MINERALS PROGRAM INSPECTION REPORT PHONE: (303) 866-3567

North Fork Pit	M-2004-025	Sand and gravel	Delta
INSPECTION TYPE:	WEATHER: Clear	INSP. DATE:	INSP. TIME:
Surety-Related Inspection		July 23, 2025	14:45
OPERATOR:	OPERATOR REPRESENTATIVE:	TYPE OF OPERATION:	
Farnsworth Construction and Gravel Compan	Patricia and Cecil Farnsworth	110c - Construction Limited Impact	
REASON FOR INSPECTION:	BOND CALCULATION TYPE:	BOND AMOUNT:	
Surety Related	None	\$22,212.00	
DATE OF COMPLANT	DOGE INGD CONTACTED	TOTALE TAKEN A CITY	ATOX7

INSPECTION TOPIC: Gen. Compliance With Mine Plan

Map 1 – Permit Boundary (black line) and AR-01 Boundary (blue shaded area) (Note that aerial photo is outdated)

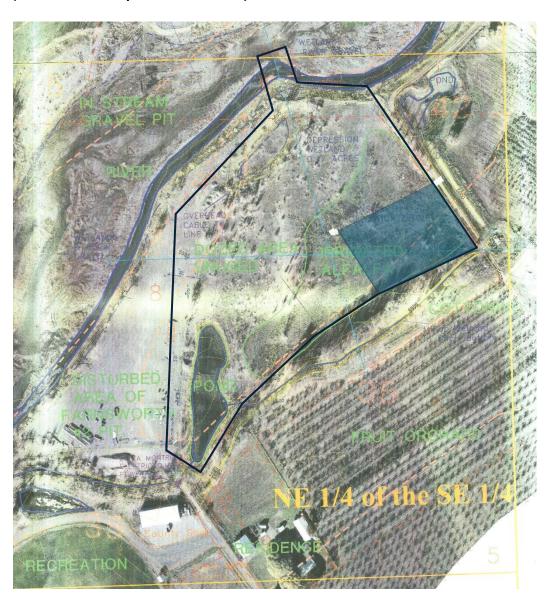
This inspection was performed for two reasons. An Acreage Reduction application, AR-01, was received June 2, 2025, and found complete on July 3, 2025. The application requests the release of 1.52 acres of unmined land from the permit area. Please see Map 1 attached to this report, which shows the permit boundary and the area that is the subject of AR-01. To satisfy the requirements of the acreage reduction process (Rule 4.17.2), Rob Zuber with the Division of Reclamation, Mining and Safety (Division) inspected the site within 60 days of the application submittal. The Division intends to make a proposed decision to approve the AR-01 application (observations discussed below). No objections or comments were received. After the approval date, the Division must wait 30 days for the appeal period to end before the approval will be finalized.

A Technical Revision (TR) is required to update the permit exhibit maps in Exhibit E showing the permit boundary, since AR-01 will reduce this area. Additional updates to permit exhibits are also required:
